## **ADDENDUM NO. 2**

DATE: January 2, 2020

PROJECT: Owosso Water Treatment Plant Wash Water Pump and Piping Replacement  
DWRP #7457-01

OWNER: City of Owosso

**P-203**

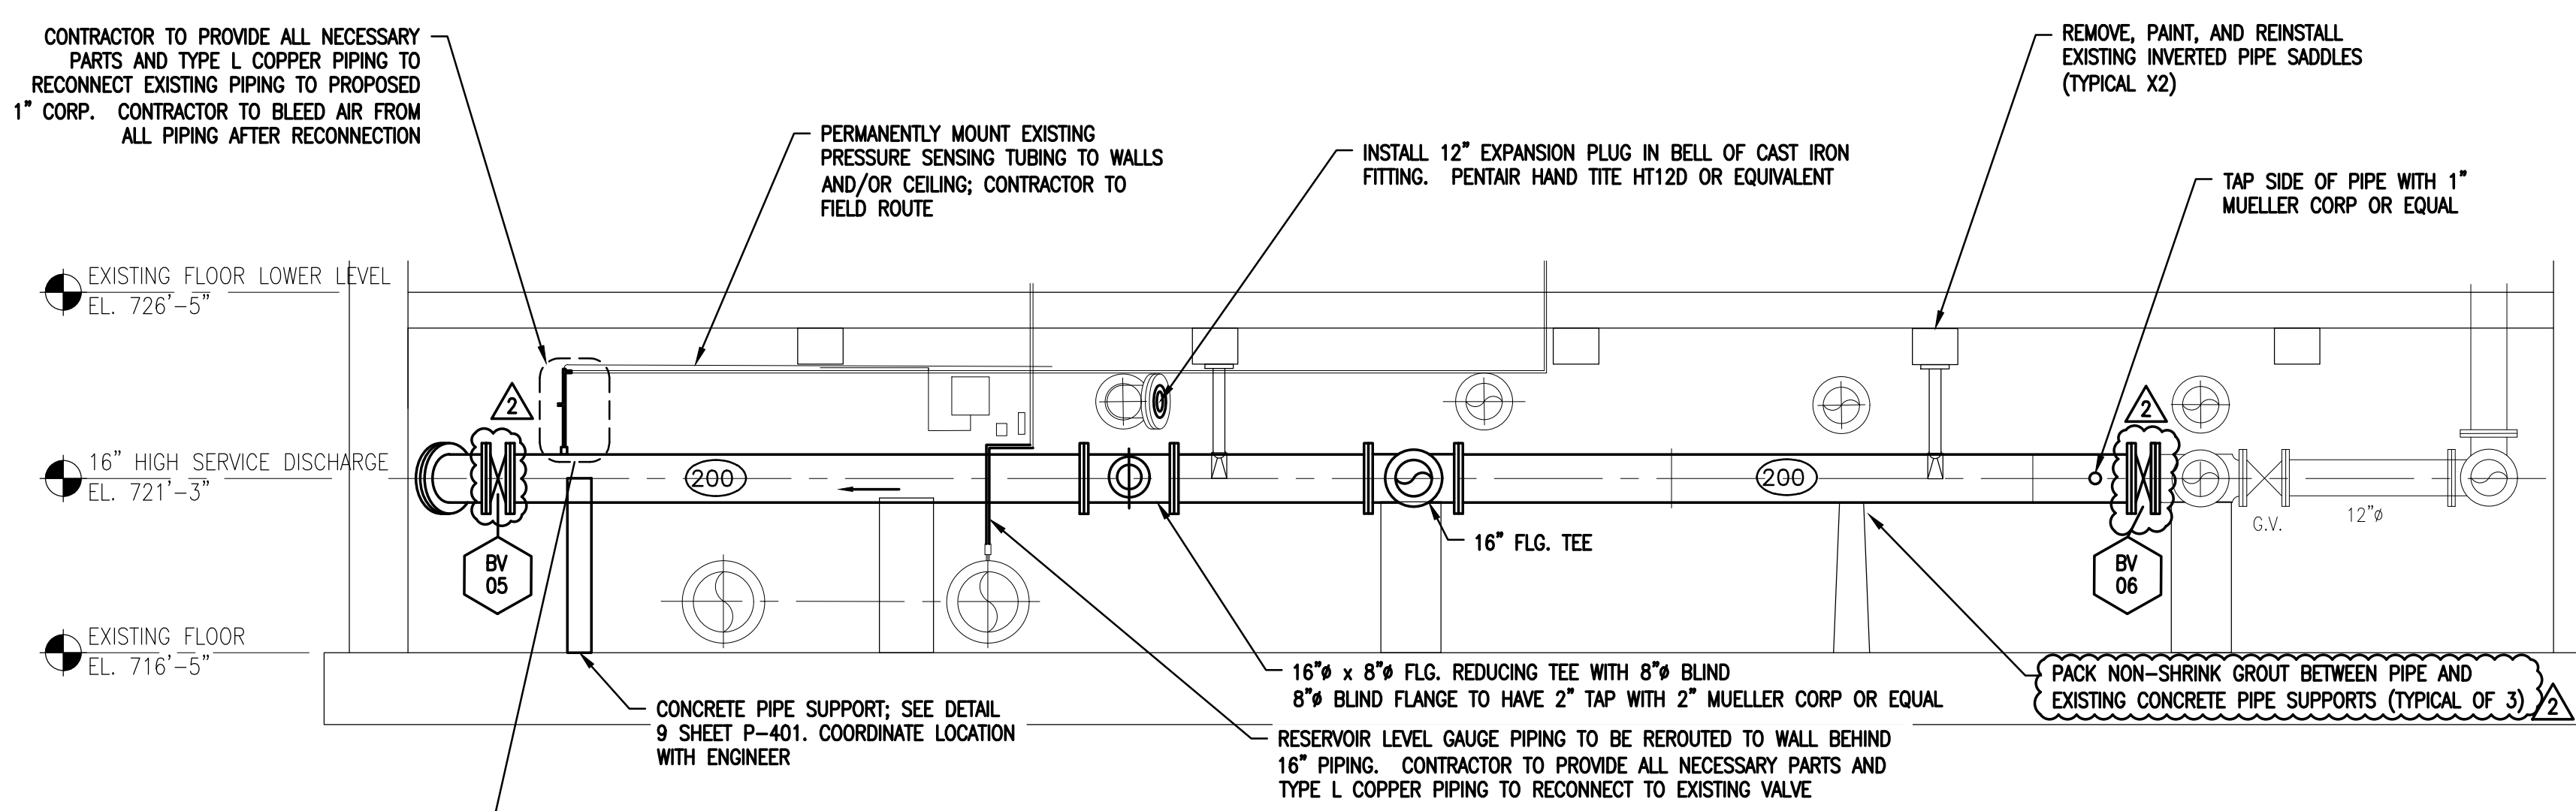
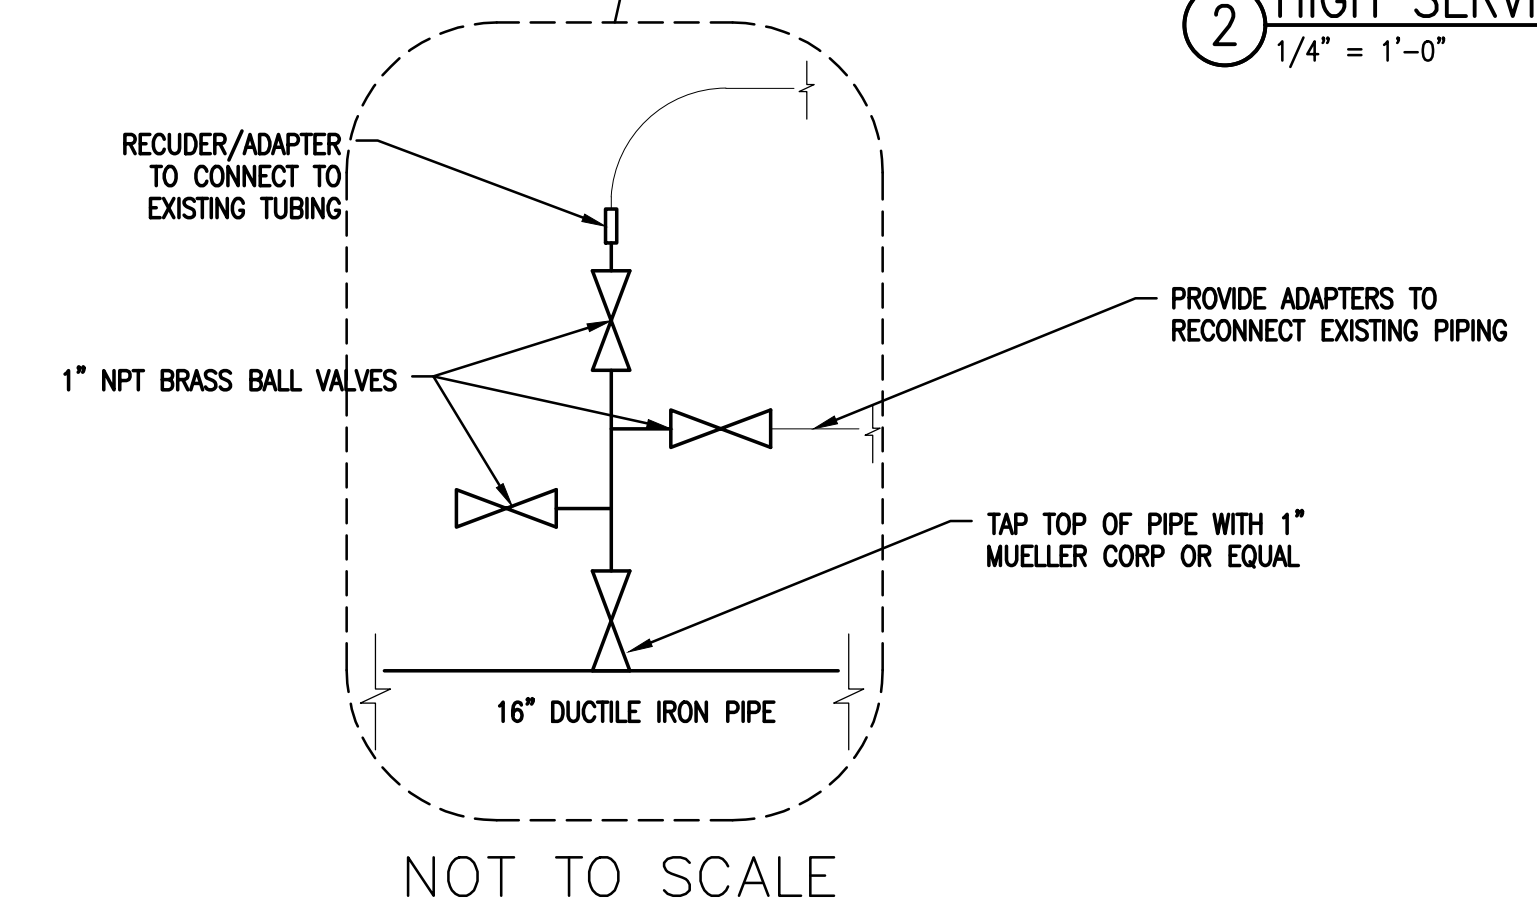
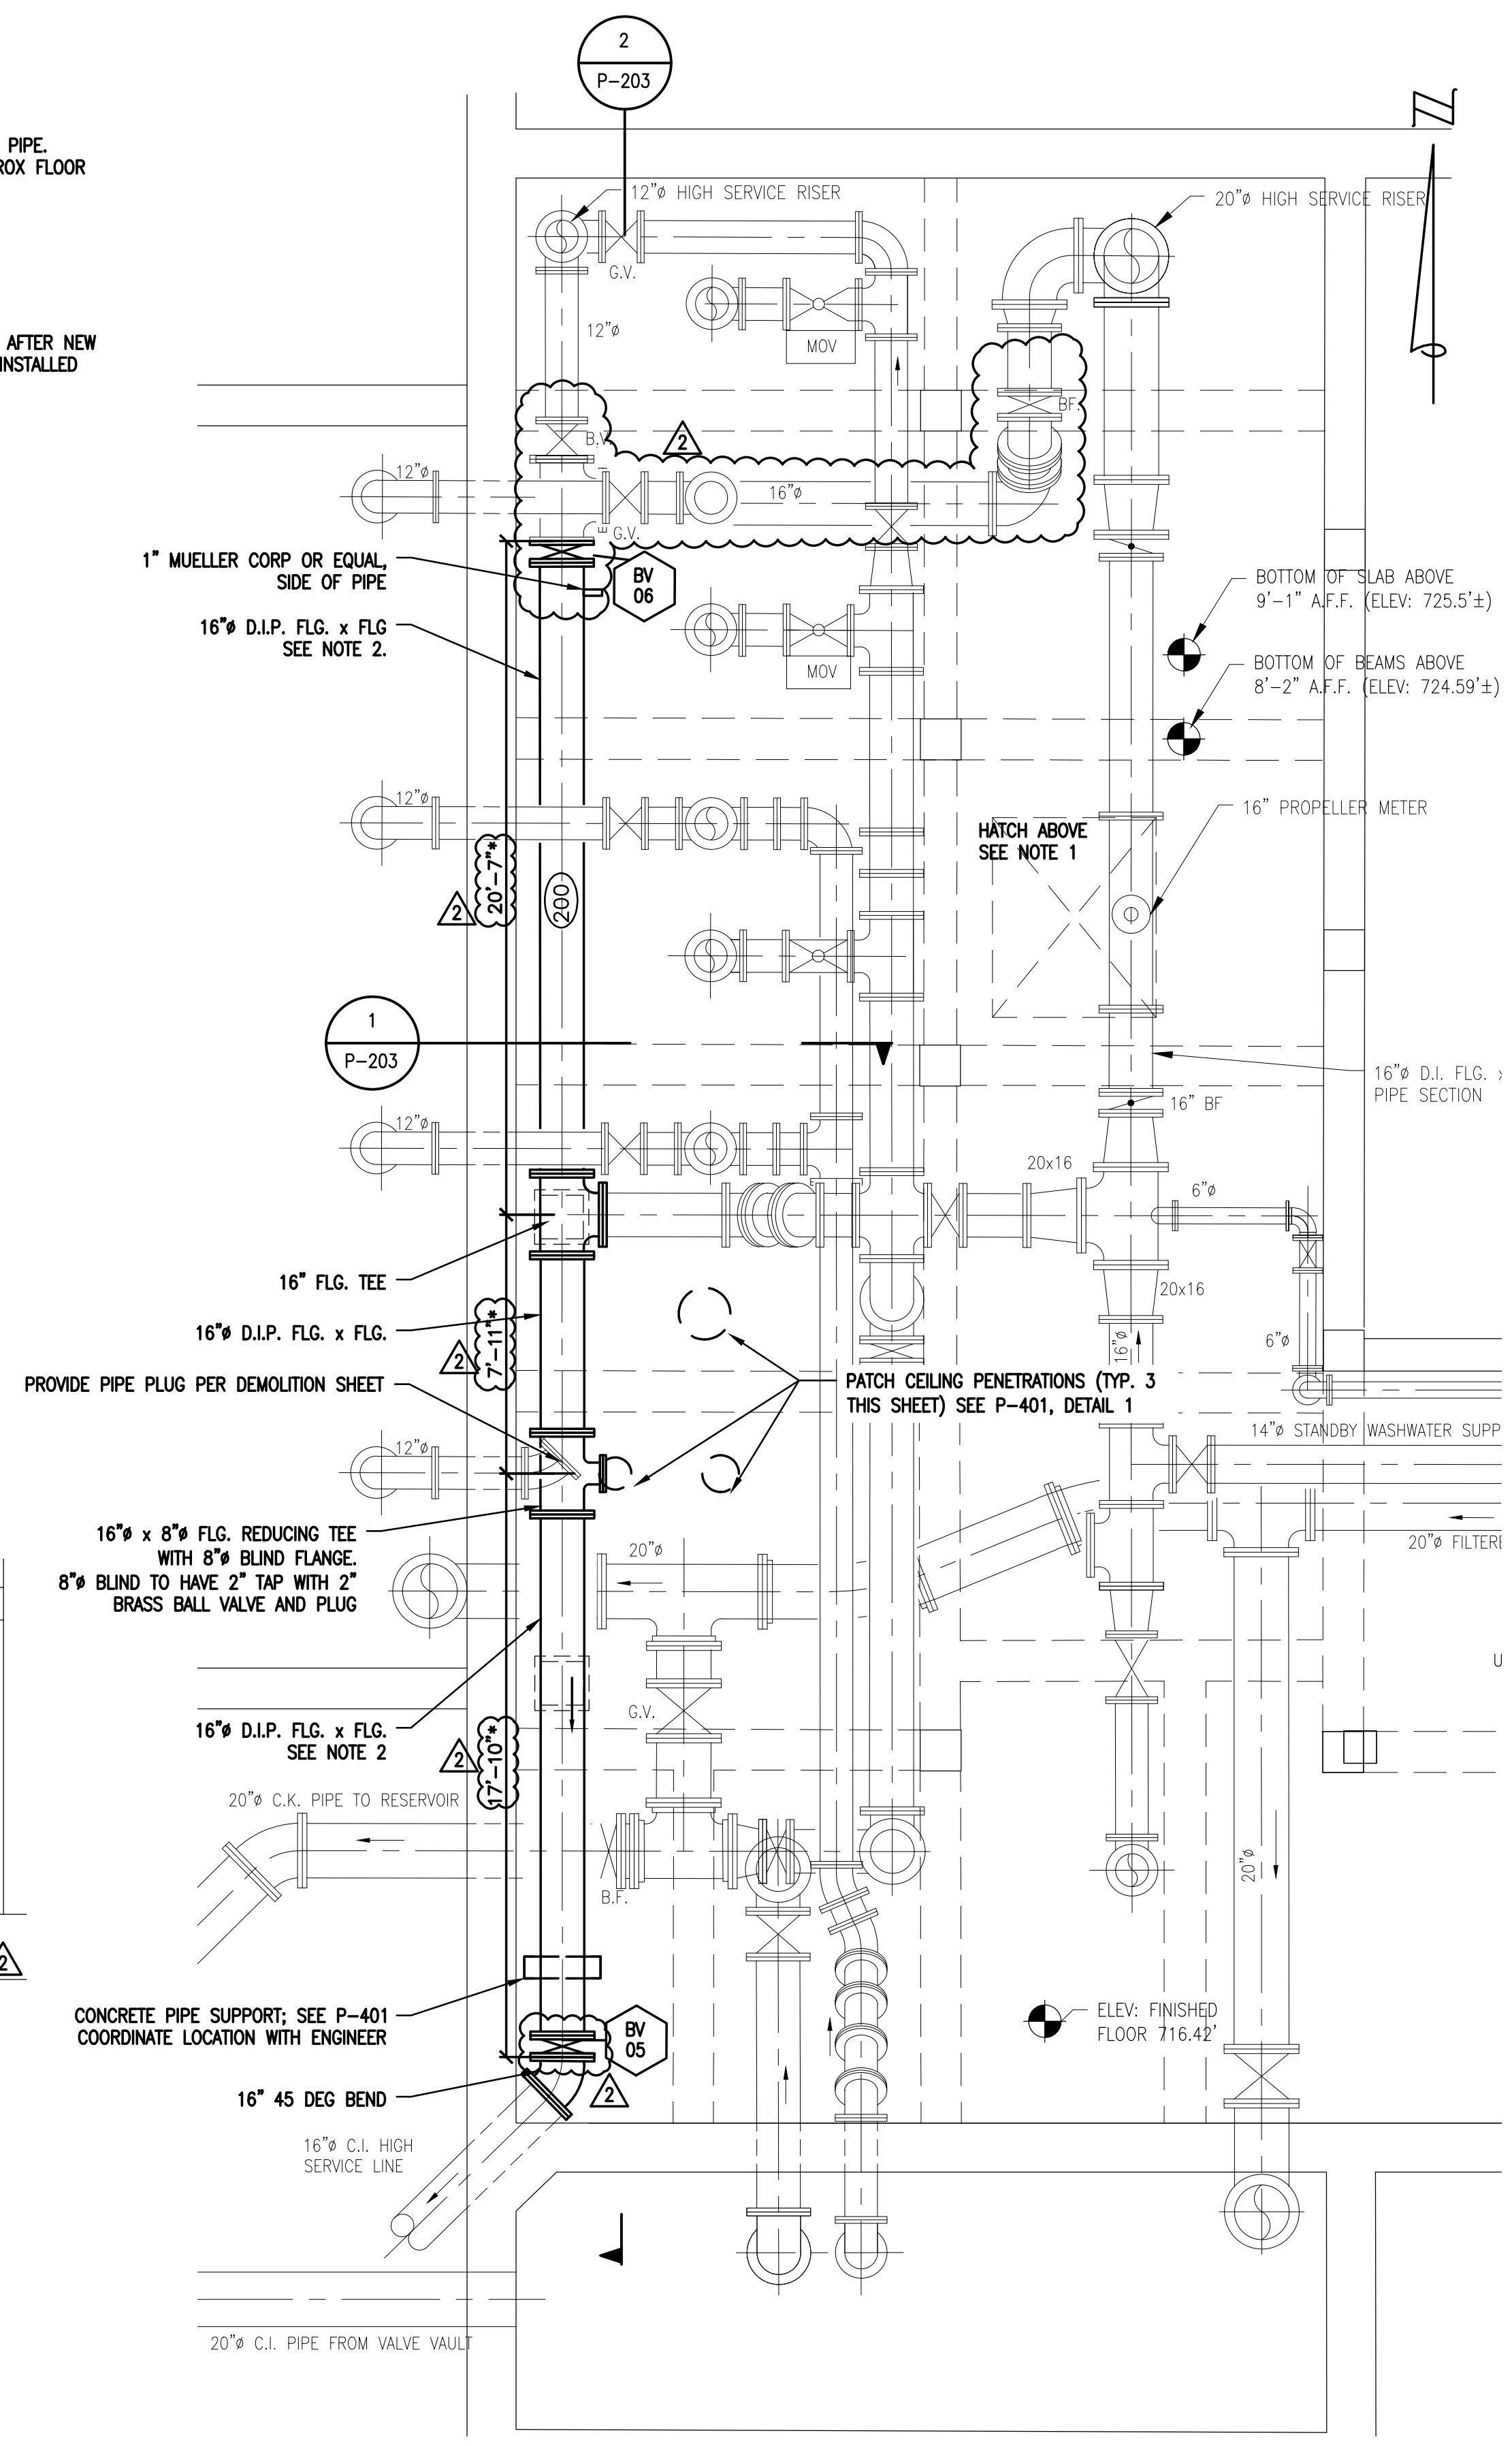
- 3. SHEET P-201 WASH WATER PUMP & PIPING PLAN & SECTIONS. Remove and replace this sheet.
- 4. SHEET P-203 HIGH SERVICE PIPE PLAN. Remove and replace this sheet.
- 5. SHEET P-301 PUMP, VALVE & PIPE SCHEDULES – change the following valve accessory

ADD PIPE SUPPORT ON 12" PIPE. SEE DETAIL 5, P-401. APPROX FLOOR TO FLANGE HEIGHT 2'-3"

ADD PIPE SUPPORT ON 12" PIPE. SEE DETAIL 5, P-401. APPROX FLOOR TO FLANGE HEIGHT 6'-1"

REMOVE I-BEAM AFTER NEW SUPPORTS ARE INSTALLED

REMOVE EXISTING PIPE SUPPORTS AFTER NEW SUPPORTS ARE INSTALLED
